# EASTLEIGH

## ADDENDUM TO MAIN REPORT

October 2018

Annotation of Illustrative sketch masterplan (June 2018) highlighting questions arising in response to the statutory consultation process

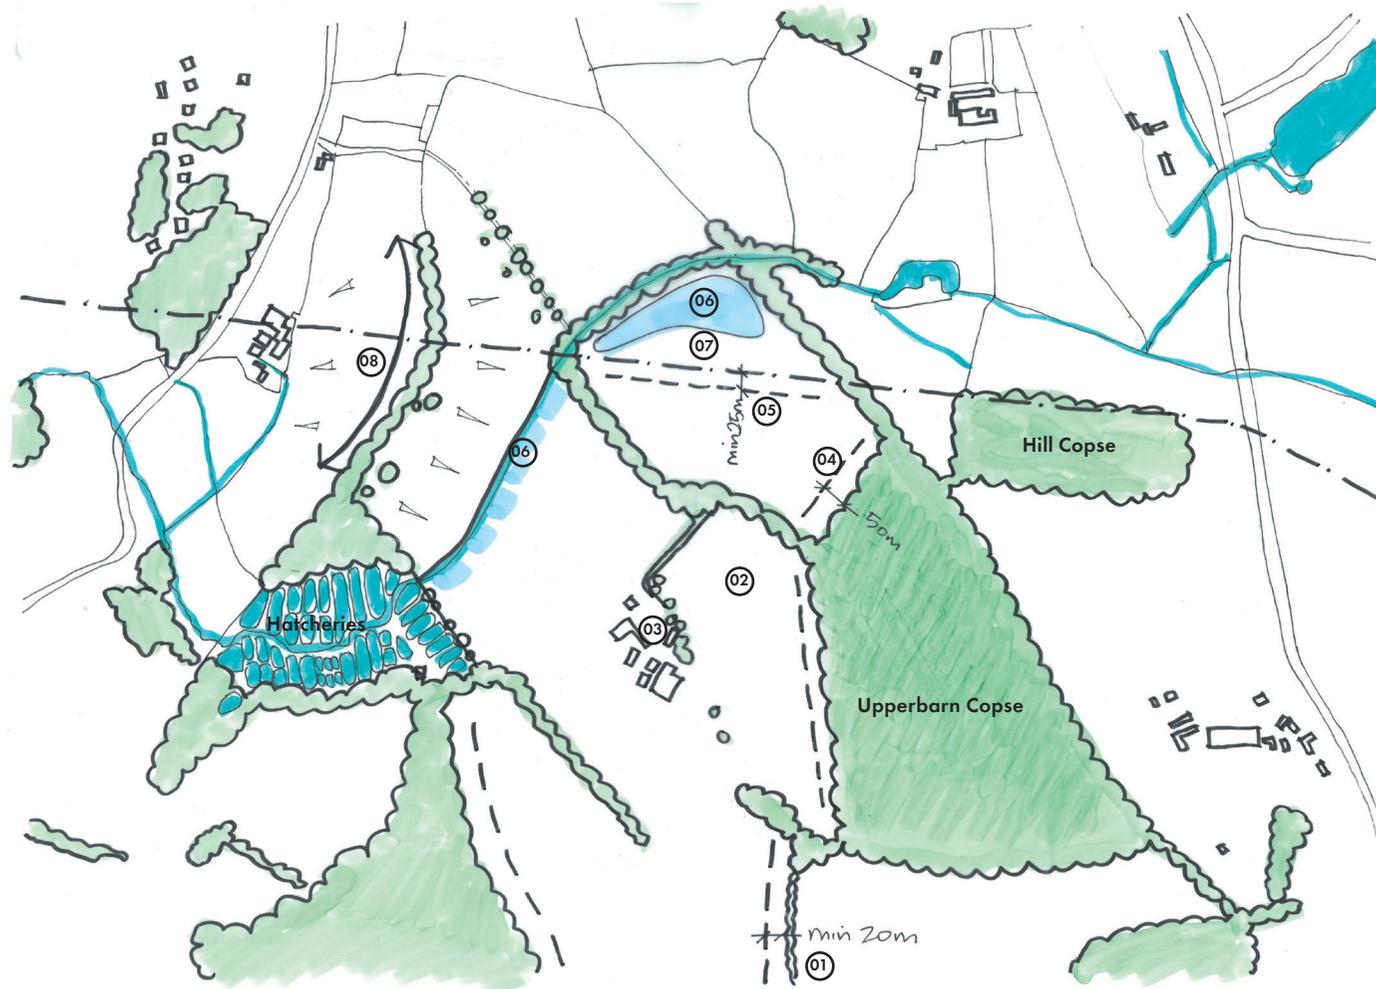
- A.** Potential to include additional development capacity subject to site constraints and mitigation.
- B.** Reduce the woodland buffer to 50m in this location to be consistent with the buffer to Stoke Park Woods along this settlement edge.
- C.** Strengthen Green Infrastructure links between the two areas of ancient woodland. Review whether this development area should be removed to strengthen ecological linkages and landscape intergrity.
- D.** Potential for combined Green Bridge and (partial)

cutting for link road in this area to provide wildlife links (especially larger mammals, deer, badgers etc, reducing collision risk), improving accessible GI for the community; and helping visual and noise mitigation of link road.

**E.** Potential additional development area, subject to review of ecological context.

**F.** Strengthen Green Infrastructure links between woodland.

**G.** Indicative additional development area: eastern extent up to proposed Countryside Gap designation within site boundary, and subject to site constraints.

## 3.1 REVISED DEVELOPMENT PARCELS

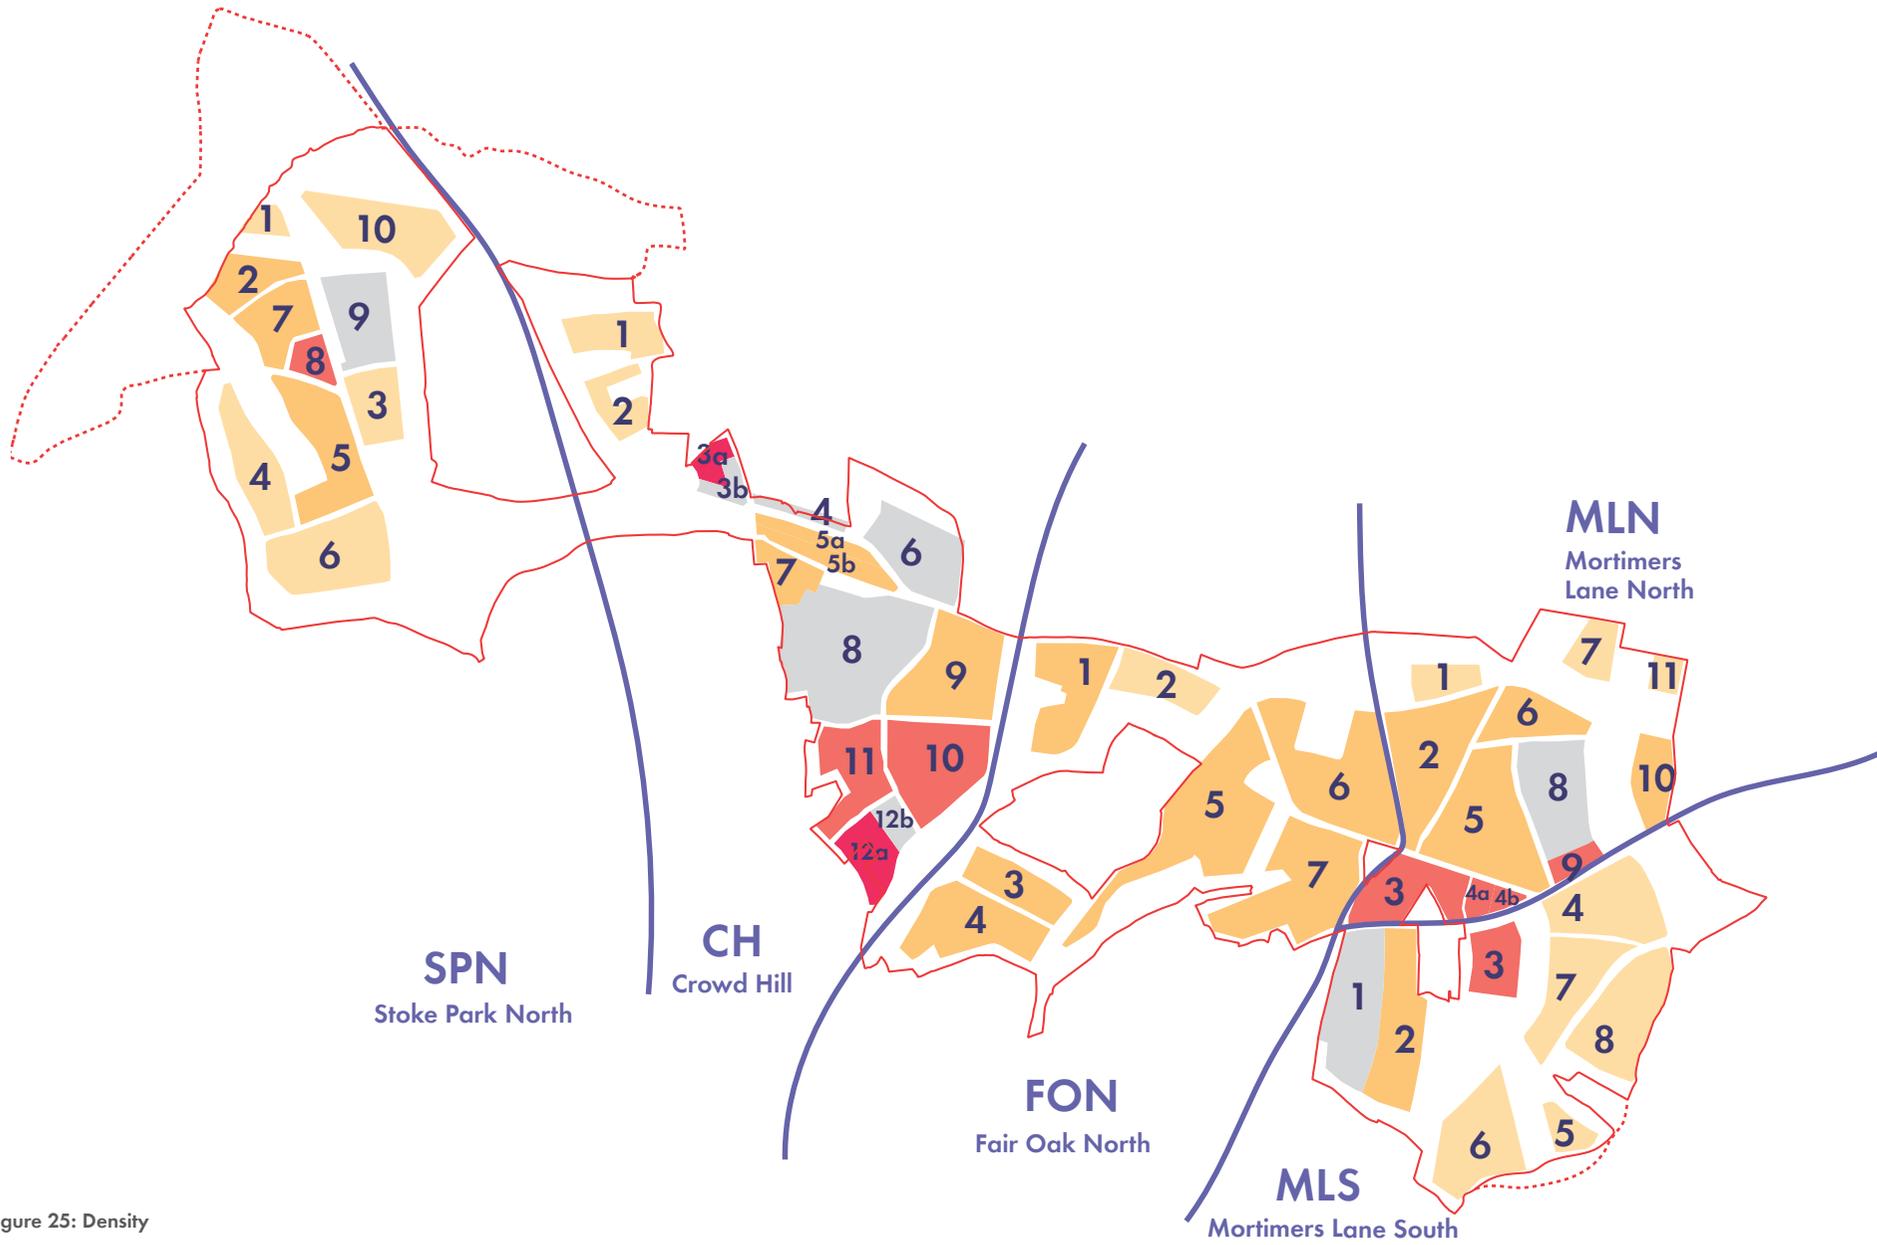
The adjacent drawing illustrates the revised indicative development parcel structure for the SGO area. The drawings in the Appendix enable comparison with the original development parcel drawing and the new version.

As noted in chapter 1, this is a simple amendment to the framework to create a consistent woodland buffer of 50m to Stoke Park. This is reflected in the amended development parcel drawings in **chapter 3**.

The strengthening of this corridor for Green Infrastructure is endorsed and embraced as a principle. This is reflected in the amended development parcel drawings in chapter 3.

EBC mark up of Illustrative sketch masterplan showing indicative approach in the SGO area

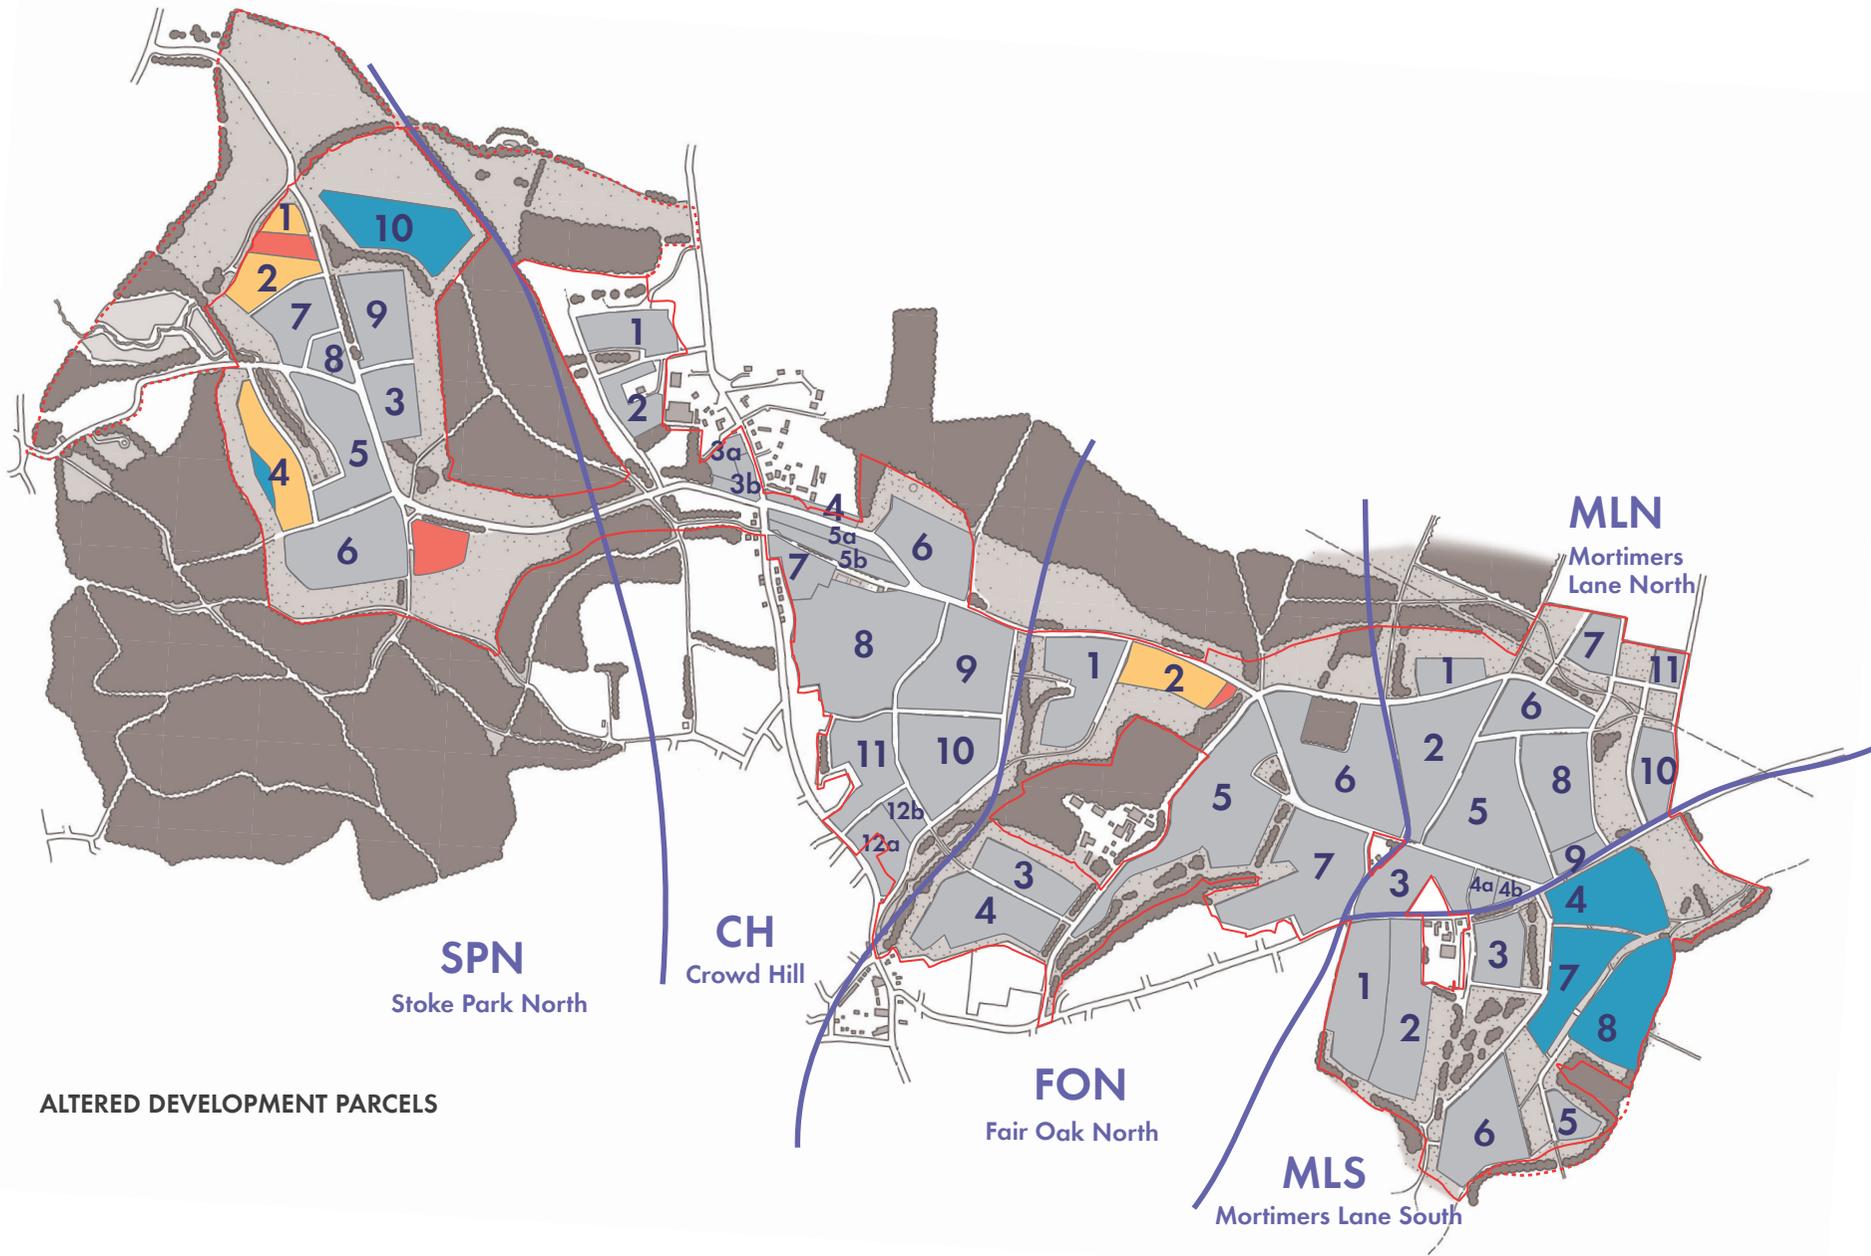
The previous total indicative capacity of the SGO was identified as up to 5,250 new homes. The new total is an increase of c. 274 homes. Of this additional capacity, approximately 100 additional dwellings have been identified at Stoke Park North, and a further 175 homes to the east of Winchester Road on the remainder of the SGO.
